In-PAD vias have a manufacturing cost :

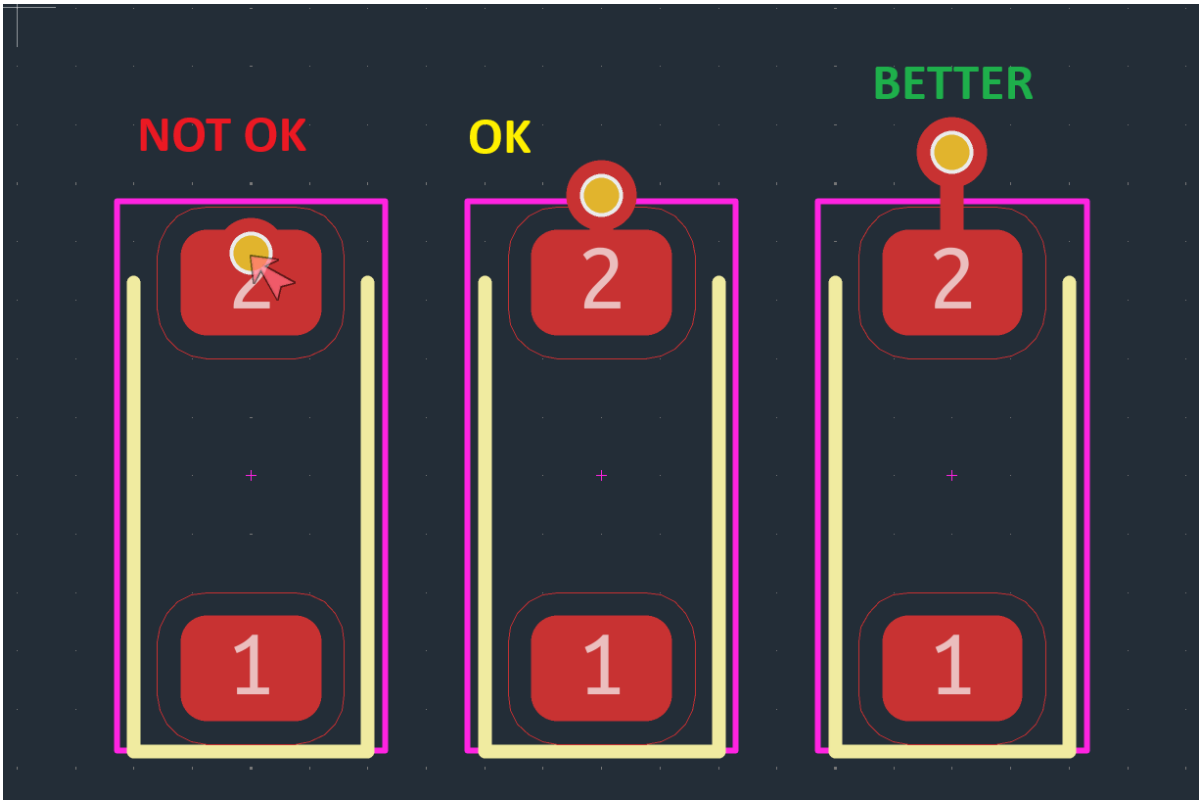
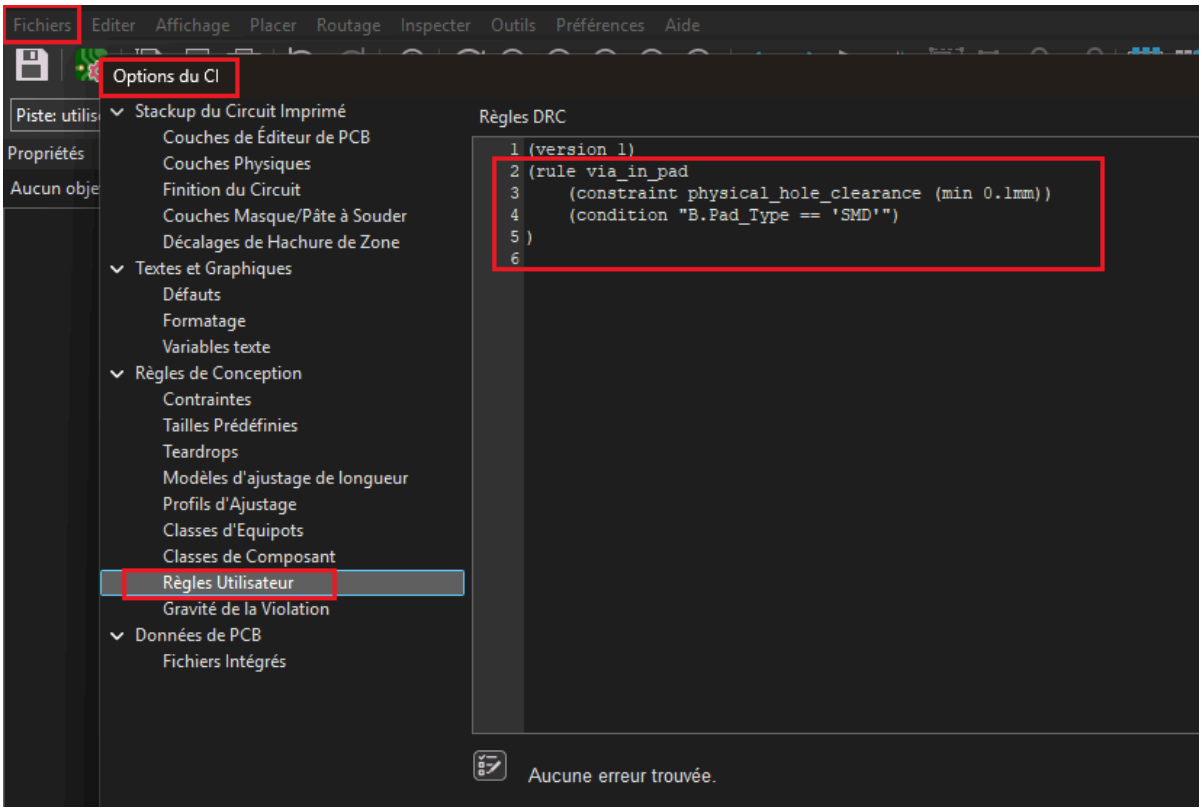
-> Add a custom rule to detect them with DRC :

```
(rule via_in_pad
    (constraint physical_hole_clearance (min 0.1mm))
    (condition "B.Pad_Type == 'SMD'")
)
```
